Access Audit Site Report

Caddo Lake State Park
245 Park Rd 2
Karnack, TX 75661
Accessibility Evaluation
Inspection Date: 04/05/2022
Inspectors: Tanya Scheibe

**TEXAS PARKS AND WILDLIFE DEPARTMENT
CADDO LAKE STATE PARK**

**AMERICANS WITH DISABILITIES ACT COMPLIANCE INITIATIVE
PROGRAM AND POLICY REPORT
JULY 28, 2023**

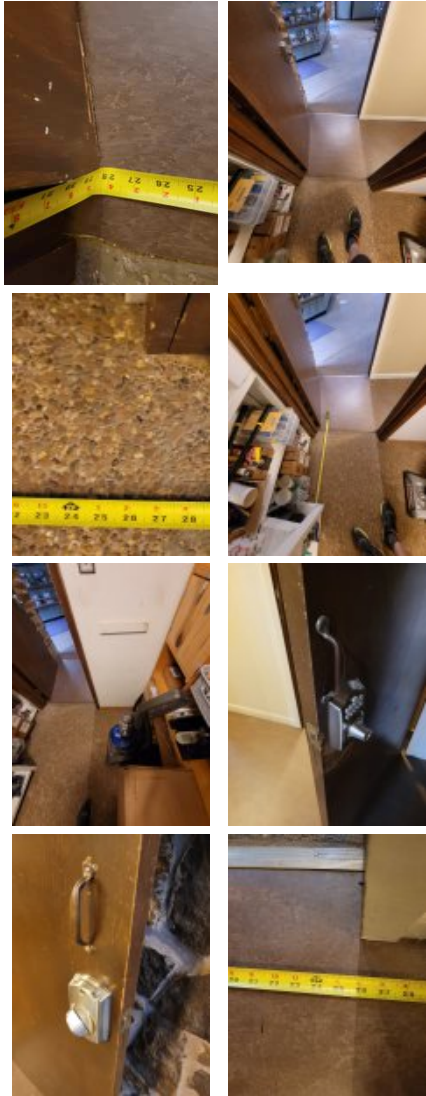
14	Headquarters Area: HQ - Public Spaces	[32.6802753 , -94.176262 6]	The landing at the bottom of the ramp has a slope greater than 2%. Bottom landings shall have a dimension in the direction of ramp run of not less than 60 inches and have a slope of less than 2% in any direction.	Entry Ramp - 3.2% slope at top landing	Correct ramp landing slope to max 2.08%.	2015 ABAAS Section: 405.7.1, 405.7.1 EXCEPTION 2012 TAS Section: 405.7.1, 405.7.1 Exception 2010 ADAS Section: 405.7.1, 405.7.1 Exception

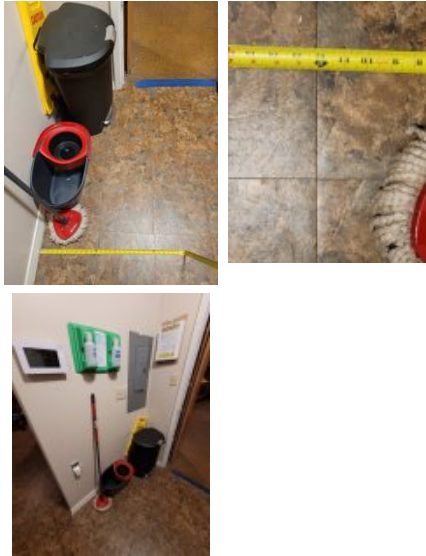
Finding Number	Area Description	Lat/Long	Finding	As Built	Recommendation	Citation	Photos	Figure
19	Headquarters Area: HQ - Employee Spaces	[32.6802166 , -94.176353 8]	Spaces and elements within employee work areas shall only be required to comply with 206.2.8, 207.1, and 215.3 and shall be designed and constructed so that individuals with disabilities can approach, enter, and exit the employee work area. Employee work areas, or portions of employee work areas, other than raised courtroom stations, that are less than 300 square feet (28 m2) and elevated 7 inches (180 mm) or more above the finish floor or ground where the elevation is essential to the function of the space shall not be required to comply with these requirements or to be on an accessible route.	Brenda office - 5.5" maneuvering clearance (MC), 30" width, .75" change in level (CIL) Behind desk area - 1" step up, MC for push half door reduced by stone wall	For employee spaces, relocate storage, furniture, and other obstacles at doorways to provide approach, enter and exit at the employee space. Provide required maneuvering clearance on push and pull side of doors. Replace doors with doors having 80" overhead clearance and 32" clear width. Repair, bevel, or ramp CILs at door entries to max .25".	2015 ABAAS Section: F203.9 2012 TAS Section: 203.9 2010 ADAS Section: 203.9

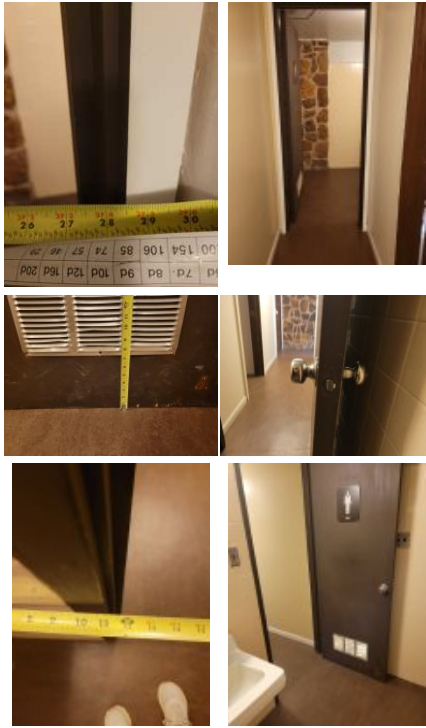
Finding Number	Area Description	Lat/Long	Finding	As Built	Recommendation	Citation	Photos	Figure
21	Headquarters Area: HQ - Employee Spaces	[32.6802798 , -94.1763108]	Spaces and elements within employee work areas shall only be required to comply with 206.2.8, 207.1, and 215.3 and shall be designed and constructed so that individuals with disabilities can approach, enter, and exit the employee work area. Employee work areas, or portions of employee work areas, other than raised courtroom stations, that are less than 300 square feet (28 m2) and elevated 7 inches (180 mm) or more above the finish floor or ground where the elevation is essential to the function of the space shall not be required to comply with these requirements or to be on an accessible route.	Storage room - 28" wide opening, 28" back clearance, pull side clearance blocked by vacuum cleaner and storage, small hardware both sides, 26" wide pull side clearance	For employee spaces, relocate storage, furniture, and other obstacles at doorways to provide approach, enter and exit at the employee space. Provide required maneuvering clearance on push and pull side of doors. Replace doors with doors having 80" overhead clearance and 32" clear width. Replace hardware with lever hardware or hardware operable without a tight pinch or grasp.	2015 ABAAS Section: F203.9 2012 TAS Section: 203.9 2010 ADAS Section: 203.9

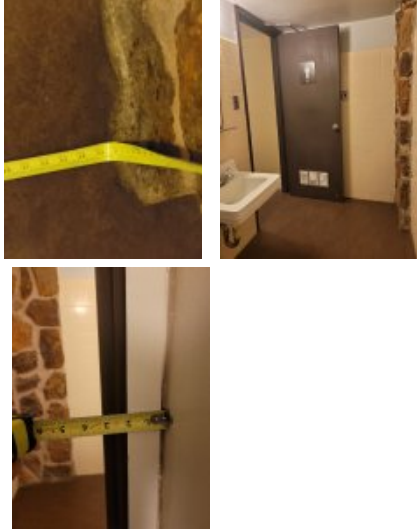
22	Headquarters Area: HQ - Employee Spaces	[32.6802708 , -94.176321 6]	Employee Work Areas. Common use circulation paths within employee work areas shall comply with 402. EXCEPTIONS: 1. Common use circulation paths located within employee work areas that are less than 1000 square feet (93 m2) and defined by permanently installed partitions, counters, casework, or furnishings shall not be required to comply with 402. 2. Common use circulation paths located within employee work areas that are an integral component of work area equipment shall not be required to comply with 402. 3. Common use circulation paths located within exterior employee work areas that are fully exposed to the weather shall not be required to comply with 402.	34.5" wide route blocked by storage	Make corrections for compliant circulation path.	2015 ABAAS Section: F206.2.8, F206.2.8.1, F206.2.8.2 2012 TAS Section: 206.2.8, 206.2.8 Exception 1, 206.2.8 Exception 2, 206.2.8 Exception 3, 206.2.8 Advisory 1, 206.2.8 Advisory 2 2010 ADAS Section: 206.2.8, 206.2.8 Exception 1, 206.2.8 Exception 2, 206.2.8 Exception 3

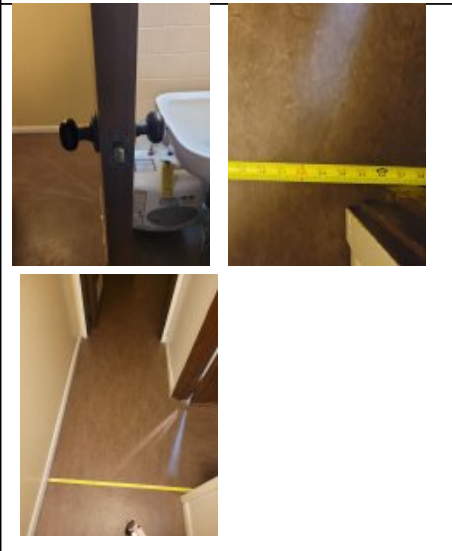
Finding Number	Area Description	Lat/Long	Finding	As Built	Recommendation	Citation	Photos	Figure
25	Headquarters Area: HQ - Employee Spaces	[32.6802618 , -94.1762894]	The operable part is not accessible because there is not adequate clear floor space for either a forward or side approach. The clear floor or ground space shall be 30 inches minimum by 48 inches minimum.	Break Room - Mop, bucket, trash can in eye wash, switch and controller CFS	Remove, or relocate storage in CFS at fixtures and operable parts..	2015 ABAAS Section: 305.3 2012 TAS Section: 305.3 2010 ADAS Section: 305.3

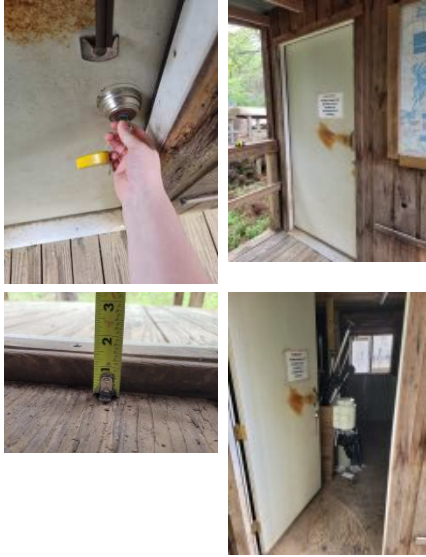
Finding Number	Area Description	Lat/Long	Finding	As Built	Recommendation	Citation	Photos	Figure
88	Day Use Area: Day Use - Canoe Launch	[32.6918516 , -94.179760 2]	There is no accessible route to the rental canoes and canoe launch/water. At least one accessible route shall connect accessible buildings, accessible facilities, accessible elements, and accessible spaces that are on the same site.	Lacks route to rental canoes and canoe launch/water	Create an accessible route with crushed stone or other outdoor material from parking or walkway to the rental canoes and canoe launch/water.	2015 ABAAS Section: F206.2.2 2012 TAS Section: 206.2.2 2010 ADAS Section: 206.2.2		
89	Day Use Area: Day Use - Canoe Launch	[32.69175, -94.179561 7]	There is a gap spaced greater than a 1/2 inch. Openings in floor or ground surfaces shall not allow passage of a sphere more than 1/2 inch diameter. Elongated openings shall be placed so that the long dimension is perpendicular to the dominant direction of travel.	1.5" gap at sloped entry to canoe launch	Correct or fill gaps to be max .5".	2015 ABAAS Section: 302.3 2012 TAS Section: 302.3 2010 ADAS Section: 302.3

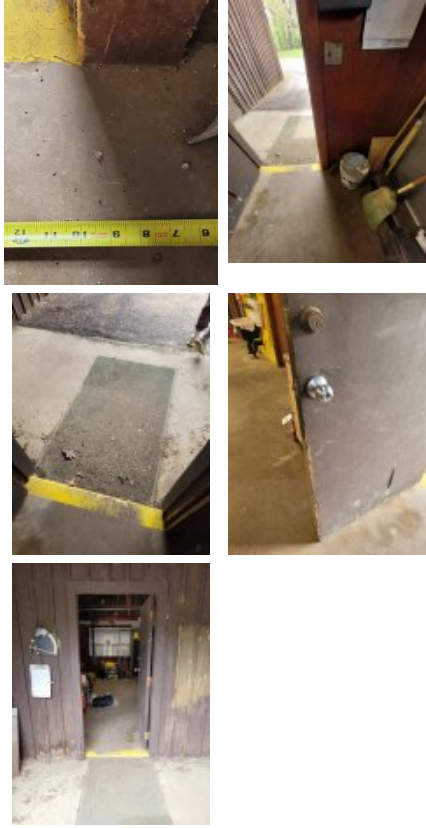
Finding Number	Area Description	Lat/Long	Finding	As Built	Recommendation	Citation	Photos	Figure
119	Day Use Area: Day Use - Amphitheater	[32.6913685 , -94.178767 8]	There is no accessible route to the amphitheater. At least one accessible route shall connect accessible buildings, accessible facilities, accessible elements, and accessible spaces that are on the same site.	Lacks AR due to rock steps	Create a ramped accessible route with crushed stone or other outdoor material from parking or walkway to the amphitheater.	2015 ABAAS Section: F206.2.2 2012 TAS Section: 206.2.2 2010 ADAS Section: 206.2.2		
120	Day Use Area: Residence	[32.6890028 , -94.177147 7]	Element meets all standards and requirements	Residence behind cabin complies	None	2010 ADAS Section: N/A		
121	Day Use Area: Residence	[32.6825058 , -94.178048 9]	Element meets all standards and requirements	Both residences by maintenance comply	None	2010 ADAS Section: N/A

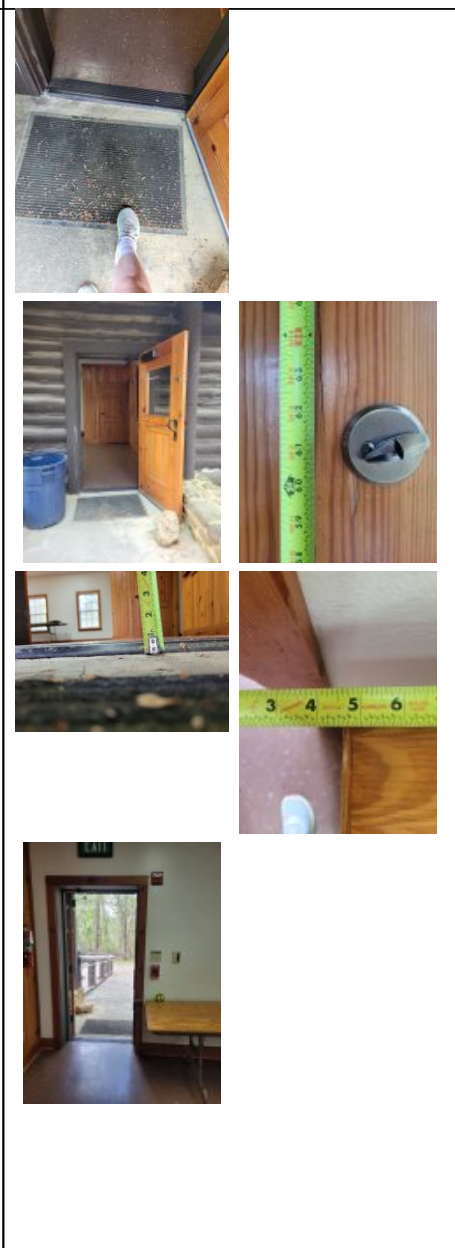
147	Group Rec Hall: Group Hall - Public Spaces	[32.68242, -94.17674]	An item or items project more than 4 inches into the circulation path. Wall-mounted objects that have leading edges between 27 inches and 80 inches from the floor must not project more than 4 inches into the circulation path. Protruding objects that extend to the floor or within 27 inches of the floor are cane detectable and are therefore not hazardous. Where it is necessary or desirable to have objects protrude from the wall, a manner of cane detection must be provided.	Drinking fountain protrudes 17.5"	Relocate protruding objects or place cane detectable warning or bollard at foot of item.	2015 ABAAS Section: 307.2 2012 TAS Section: 307.2 2010 ADAS Section: 307.2

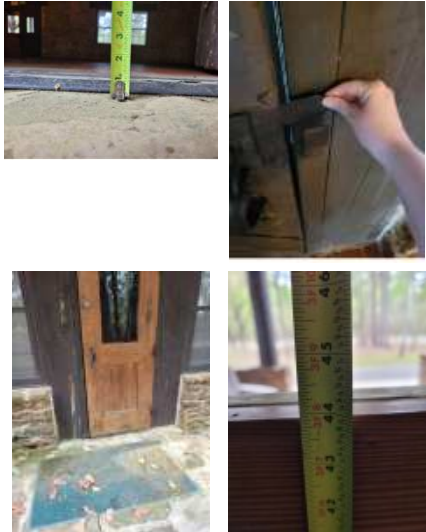
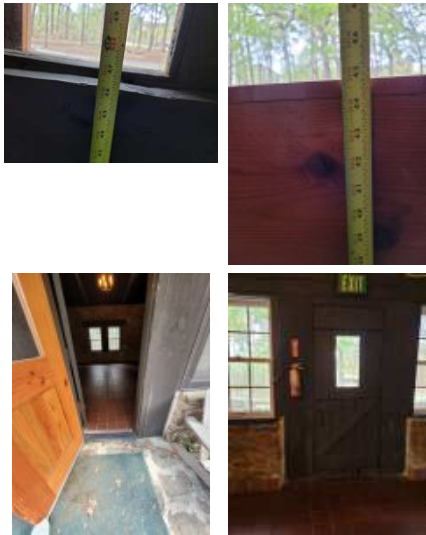
Finding Number	Area Description	Lat/Long	Finding	As Built	Recommendation	Citation	Photos	Figure
152	Group Rec Hall: Group Hall - Public Spaces	[32.68242, -94.17674]	<p>The sink is not accessible. A clear floor space at least 30 inches by 48 shall be provided in front of a sink to allow forward approach. -The clear floor space shall be on an accessible route and shall extend a maximum of 19 inches underneath the sink.</p> <p>-Sinks shall be mounted with the counter or rim no higher than 34 inches above the finish floor. -Knee clearance at least 27 inches high, 30 inches wide and 19 inches deep shall be provided. -Hot water and drain pipes exposed under sinks shall be insulated or otherwise configured so as to protect against contact. There shall be no sharp or abrasive surfaces under sinks.</p> <p>-Faucet controls not require tight grasping, pinching or twisting of the wrist. -The force required to activate controls shall be not greater than 5 lb. Lever-operated, push-type and electronically controlled mechanisms are examples of acceptable designs. -Self-closing valves are allowed if the faucet remains open for at least 10 seconds.</p>	Kitchen - sink lacks CFS due to movable island location	Relocate items to provide CFS at sink.	<p>2015 ABAAS Section: 606.2, 606.2 EXCEPTION S: 1, 606.2 EXCEPTIONS: 4, 606.2 EXCEPTIONS: 5, 606.2 EXCEPTIONS: 6, 606.2 EXCEPTIONS: 7, 606.3, 606.4, 606.5</p> <p>2012 TAS Section: 606.2, 606.2 Exception 1, 606.2 Exception 4, 606.2 Exception 5, 606.2 Exception 6, 606.2 Exception 7, 606.3, 606.4, 606.5</p> <p>2010 ADAS Section: 606.2, 606.2 Exception 1, 606.2 Exception 4, 606.2 Exception 5, 606.2 Exception 6, 606.2 Exception 7, 606.3, 606.4, 606.5</p>

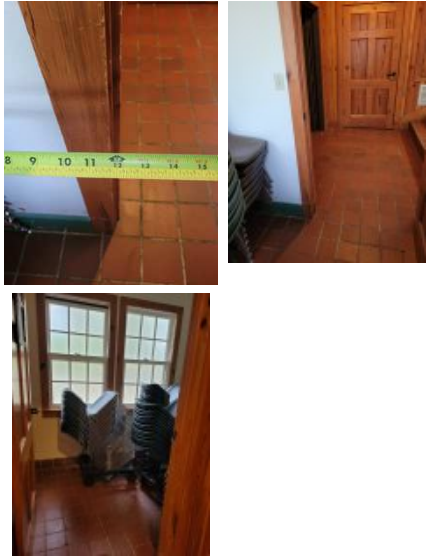
160	Group Rec Hall: Group Hall - Public Spaces	[32.68242, -94.17674]	Openings in floor or ground surfaces shall not allow passage of a sphere more than 1/2 inch (13 mm) diameter except as allowed in 407.4.3, 409.4.3, 410.4, 810.5.3 and 810.10. Elongated openings shall be placed so that the long dimension is perpendicular to the dominant direction of travel.	.5" gap by black double doors from main room to kitchen side	Fill and maintain gaps to max .5".	2015 ABAAS Section: 302.3 2012 TAS Section: 302.3 2010 ADAS Section: 302.3

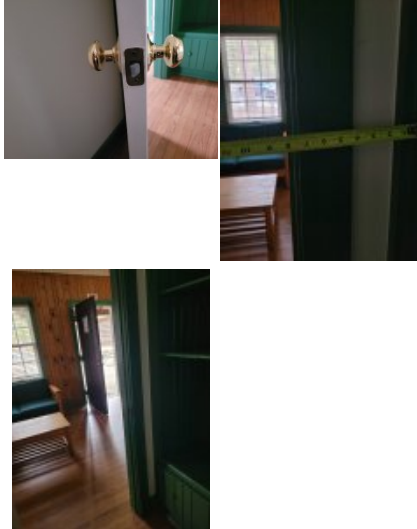
Finding Number	Area Description	Lat/Long	Finding	As Built	Recommendation	Citation	Photos	Figure
191	Cabin Sites: Cabins - Parking	[32.6846098 , -94.177595 6]	Element meets all standards and requirements	Parking meets scoping requirements - 3 standard (and 2 RV), 1 accessible comply	None	2010 ADAS Section: N/A		
192	Cabin Sites: Cabins - Parking	[32.6845748 , -94.177605]	The cross slopes (narrow dimension) and/or running slopes (long dimension) of the access aisle exceeds 2%. The running slope and the cross slope in an accessible parking stall and the access aisle must not exceed 2%.	AA - 8% at storm drain, stall - 6.5%	Repair or correct slope of parking space and access aisle to max 2.08% in any direction.	2015 ABAAS Section: 502.4 2012 TAS Section: 502.4 2010 ADAS Section: 502.4		
193	Cabin Sites: Cabins - Parking	[32.6850026 , -94.177539 3]	The parking stall contains abrupt edges and surface irregularities over a 1/4 inch vertical. Parking spaces and access aisles serving them shall be stable, firm, and slip resistant. Access aisles shall be at the same level as the parking spaces they serve. Changes in level are not permitted and shall not be sloped steeper than 2% in any direction.	Storm drain causes surface irregularities	Resurface access aisle to eliminate surface irregularities, or relocate to an area without a drain.	2015 ABAAS Section: 502.4 2012 TAS Section: 502.4 2010 ADAS Section: 502.4

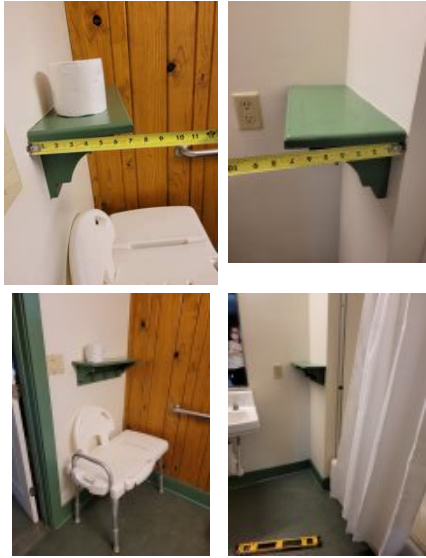
203	Cabin Sites: Cabins - Cabin 3	[32.68242, -94.17674]	The operable part is positioned too high for either a side or front approach. Where a clear floor or ground space allows a parallel approach to an element and the side reach is unobstructed, the high side reach shall be 48 inches maximum and the low side reach shall be 15 inches minimum above the finish floor or ground. Where a forward reach is unobstructed, the high forward reach shall be 48 inches maximum and the low forward reach shall be 15 inches minimum above the finish floor or ground.	Kitchen - Microwave at 66" AFF	Relocate microwave for operable parts to be in reach range of 15" min to 48" max.	2015 ABAAS Section: 308.1 2012 TAS Section: 308.1 2010 ADAS Section: 308.1

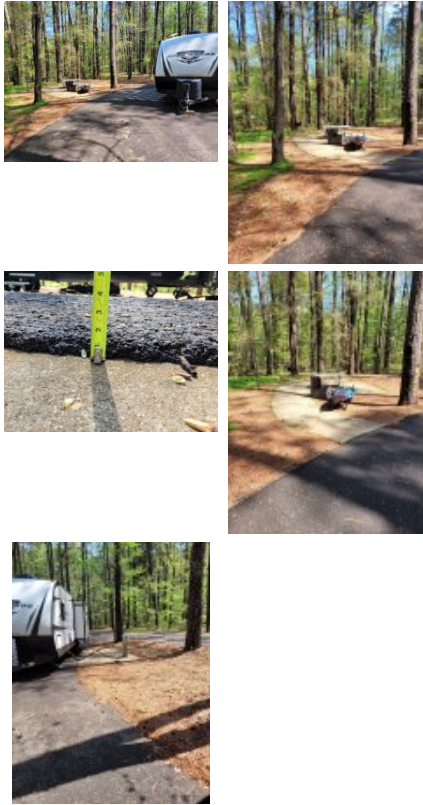
Finding Number	Area Description	Lat/Long	Finding	As Built	Recommendation	Citation	Photos	Figure
261	Cabin Sites: Cabins - Dump Station	[32.68583, -94.1780073]	30 inches (760 mm) by 60 inches (1525 mm) with the long side of the space adjoining or overlapping an accessible parking space or pull-up space for recreational vehicles. Locate the space so that the hook-ups are at the rear center of the space. Bollards or other barriers shall not obstruct the clear ground space in front of the hook-ups	22.4% and 18.1% slope at dump station and water spigot	Correct or repair slopes in utility CFS to max 2.08%.	2015 ABAAS Section: 1011.2		
262	Cabin Sites: Cabins - Picnic Area	[32.68618, -94.1786]	There is no accessible route to the picnic tables. At least one accessible route shall connect accessible buildings, accessible facilities, accessible elements, and accessible spaces that are on the same site. Picnic tables shall provide at least one wheelchair space for each 24 linear feet (7320 mm) of usable table surface perimeter. Wheelchair spaces shall be 30 inches (760 mm) minimum by 48 inches (1220 mm) minimum. Wheelchair spaces shall be positioned for a forward approach to the table and provide knee and toe clearance complying with 306 under the table.	0 of 7 picnic tables and 0 of 3 have AR	Create an accessible route with crushed stone or other outdoor material from parking or walkway to 2 picnic tables. Replace 2 picnic table with ones of an accessible design as a smart practice.	2015 ABAAS Section: F206.2.2 2012 TAS Section: 206.2.2 2010 ADAS Section: 206.2.2

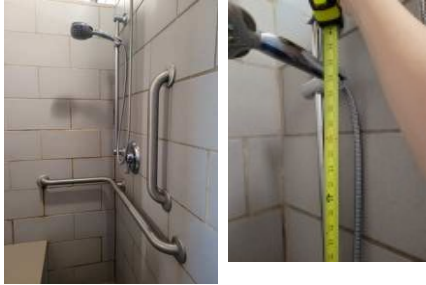
291	Woodpecker Hollow Camping Area: Woodpecker Hollow - Women's Restroom	[32.68242, -94.17674]	An item or items project more than 4 inches into the circulation path. Wall-mounted objects that have leading edges between 27 inches and 80 inches from the floor must not project more than 4 inches into the circulation path. Protruding objects that extend to the floor or within 27 inches of the floor are cane detectable and are therefore not hazardous. Where it is necessary or desirable to have objects protrude from the wall, a manner of cane detection must be provided.	Shelf projects 4.25"	Relocate protruding objects or place cane detectable warning or bollard at foot of item.	2015 ABAAS Section: 307.2 2012 TAS Section: 307.2 2010 ADAS Section: 307.2		
292	Woodpecker Hollow Camping Area: Woodpecker Hollow - Women's Restroom	[32.68242, -94.17674]	The grab bar is located above the seat In alternate roll-in type shower compartments, grab bars shall be provided on the back wall and the side wall farthest from the compartment entry. Grab bars shall not be provided above the seat. Grab bars shall be installed 6 inches maximum from adjacent walls.	Grab bar doesn't extend all the way across back wall	Provide grab bars in the shower mounted in the correct locations for the shower type.	2015 ABAAS Section: 608.3.3 2012 TAS Section: 608.3.3 2010 ADAS Section: 608.3.3
